# ADDENDUM No. 1

ITB No. 4618

## Landfill Scale and Entrance Improvements

# LANDFILL SCALE AND ENTRANCE IMPROVEMENTS

PROPOSED SITE PLAN

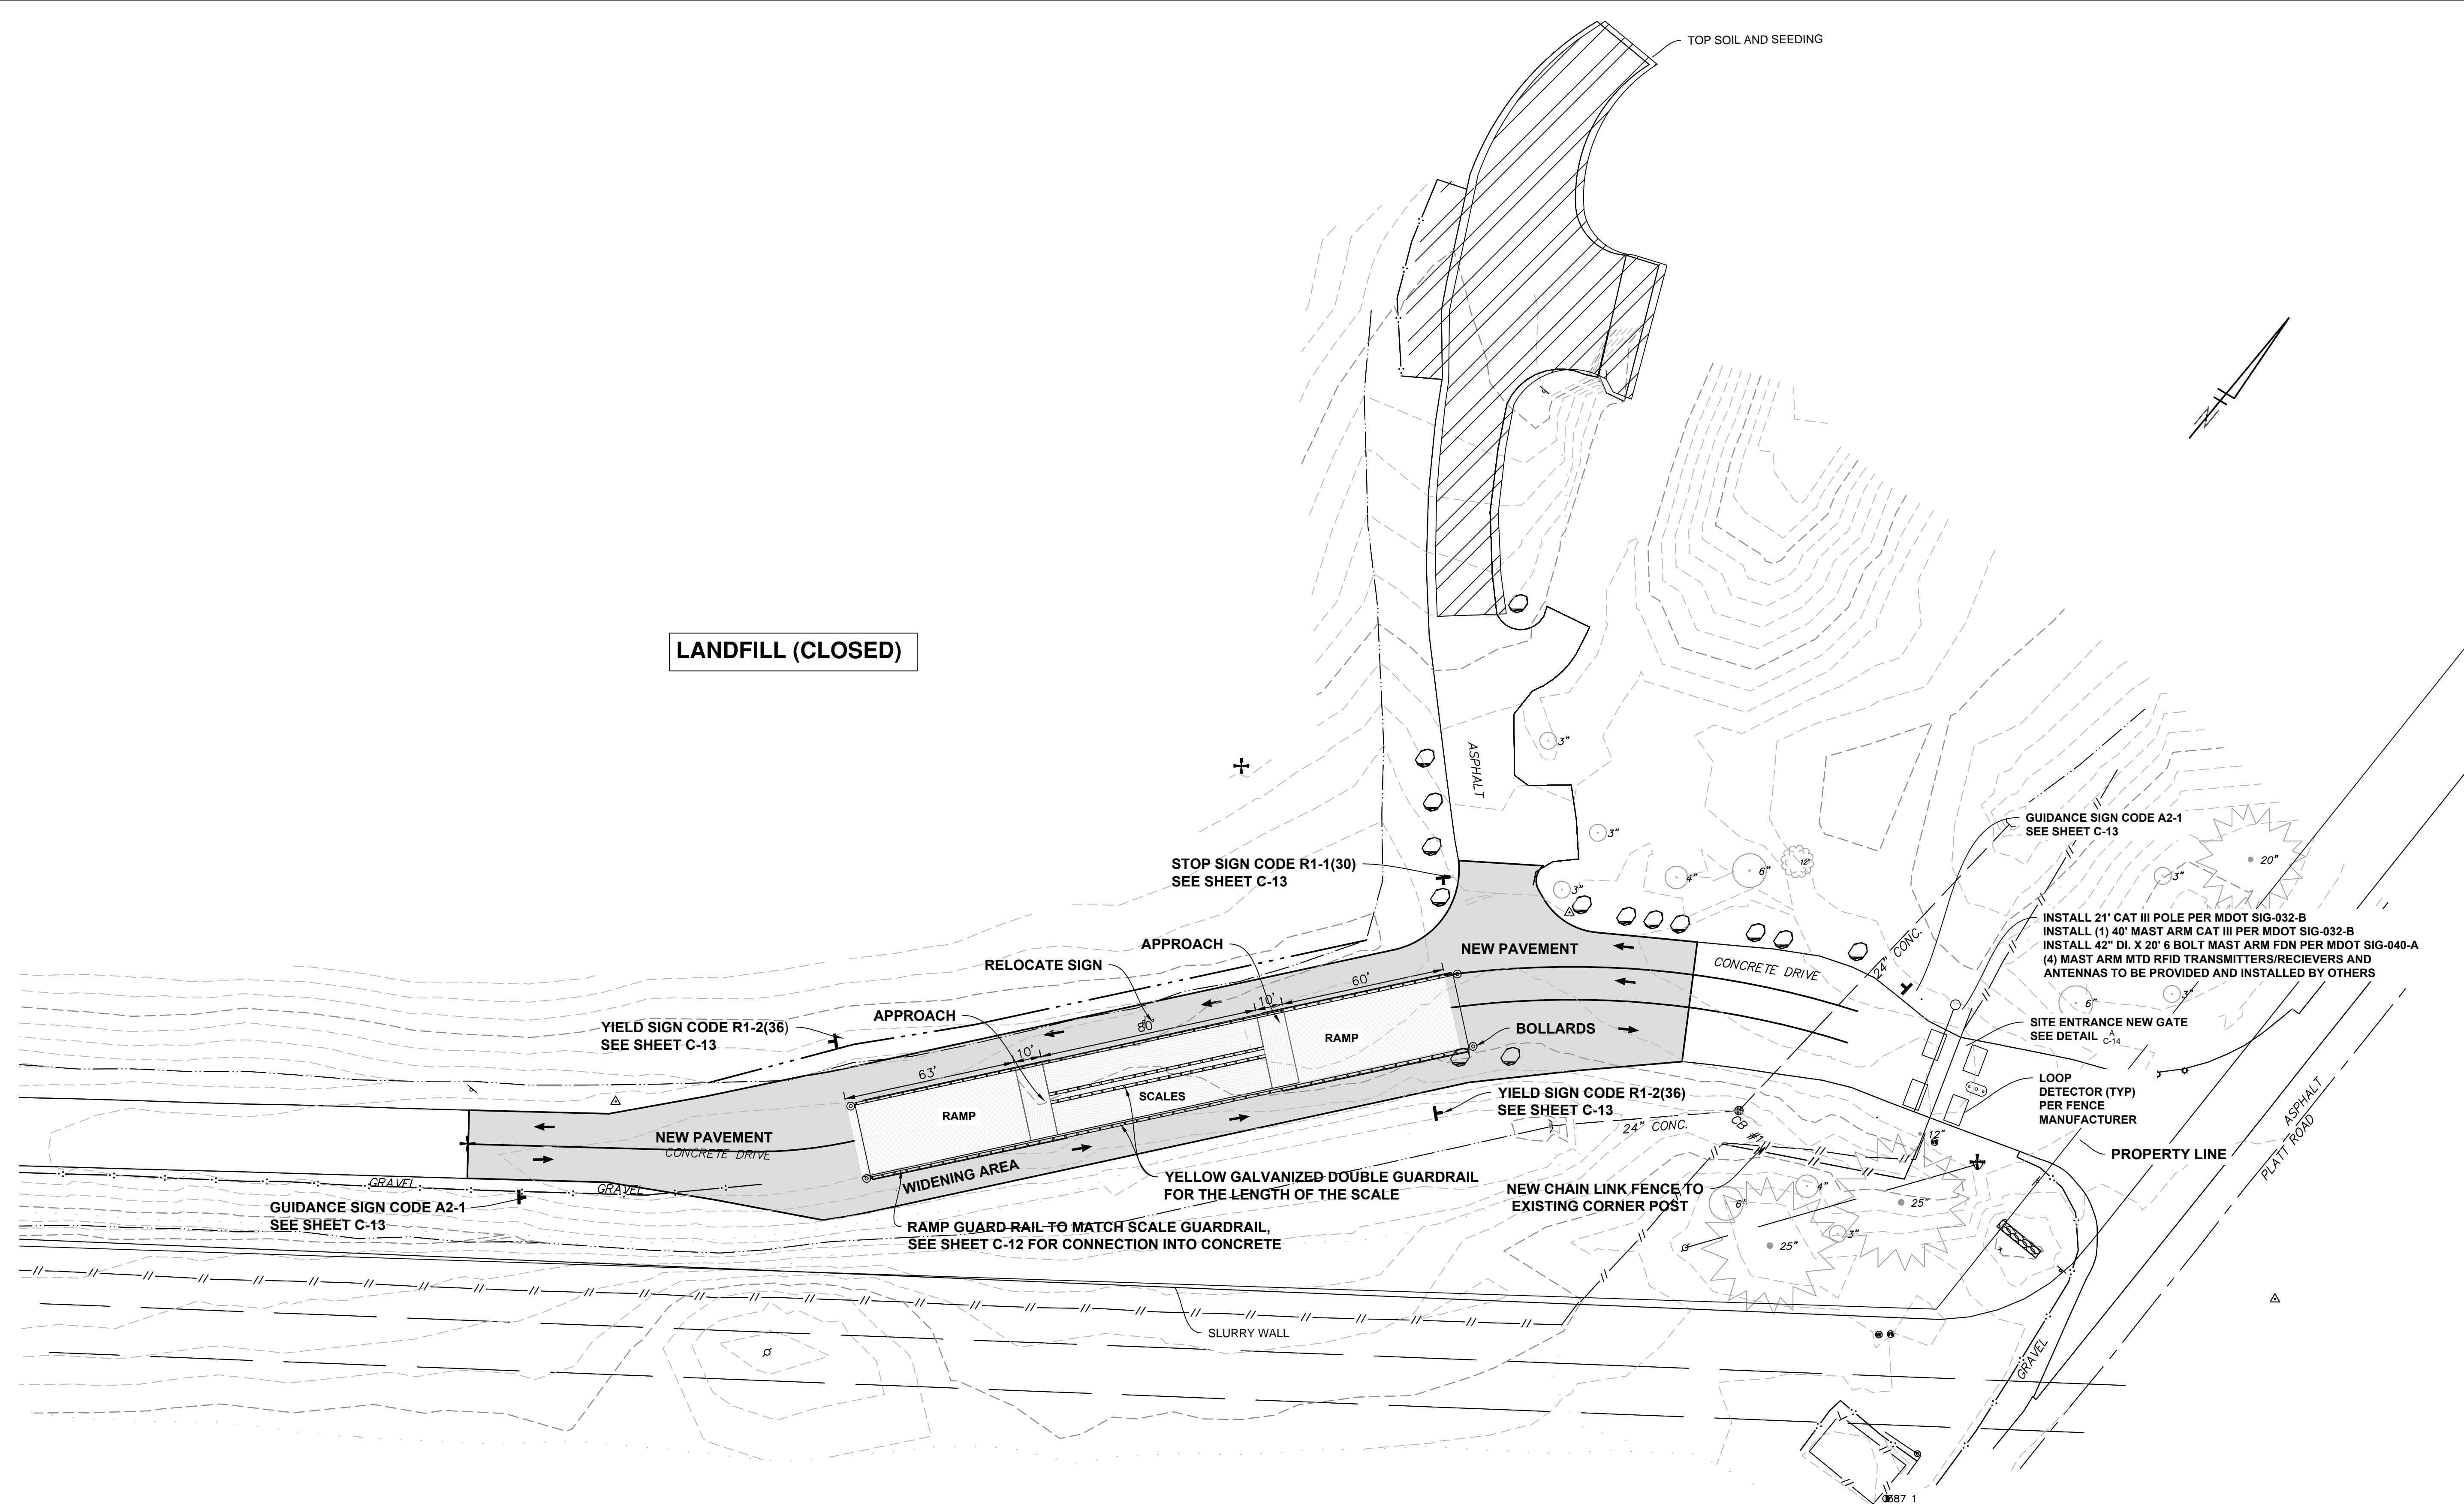
Please provide a specification section as it relates to the proposed guardrail. Also, please provide the coating requirements for the guardrail system and a connection detail (to the scale foundation system).

See notes on Sheet C-05 for the guardrail requirements. The guardrail shall be per the scale manufacturer requirements and shall be yellow galvanized steel.

**SCALE FOUNDATION PLAN**

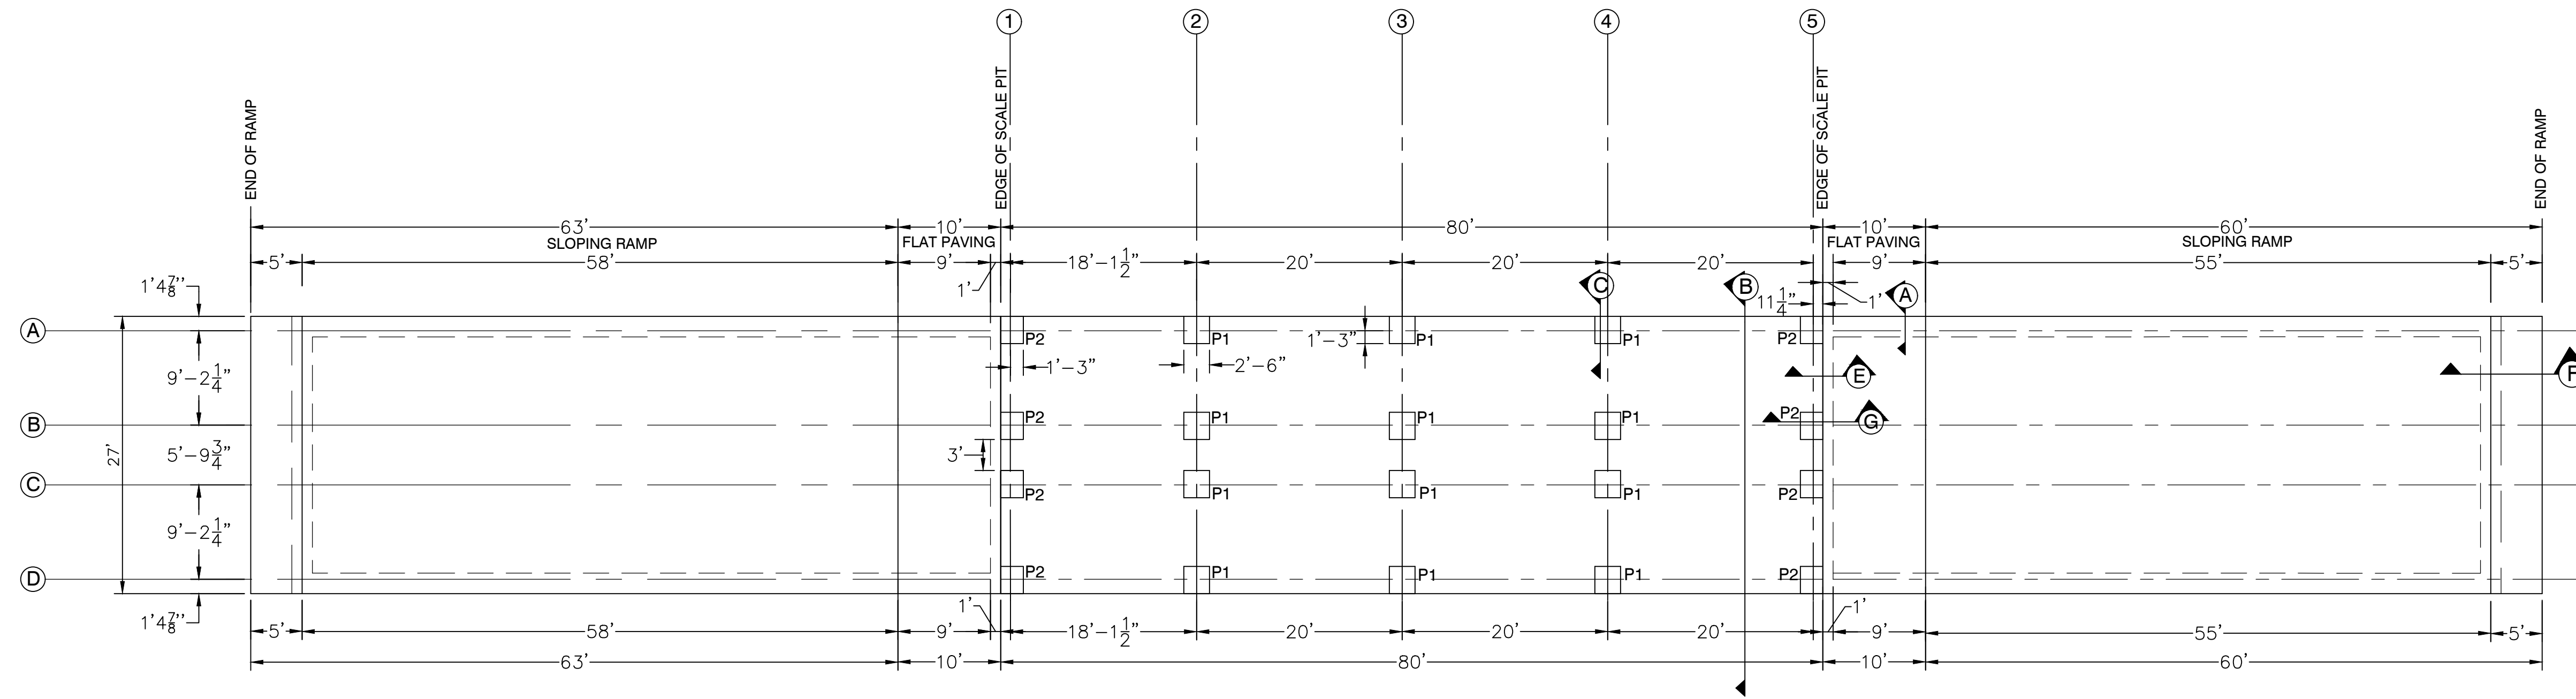
Can you verify the width of each truck scale. While looking at sheet C-10 (scale Foundation Plan) I noticed it shows 12' wide. My quote from last year show 80' x 11'.80' x 11' or 80' x 12' for the truck scales.

The intent is providing two scales with weighbridge dimensions 80’ long by 12’ wide. Railing is required on each side of each scale. The contractor must verify the railings will fit between the scales. The profile of the scale should be what is required to meet the intended use. It can be low profile or high profile. We assume some modification of the structural supports may be required after bid award due to variations in scale dimensions by various suppliers.
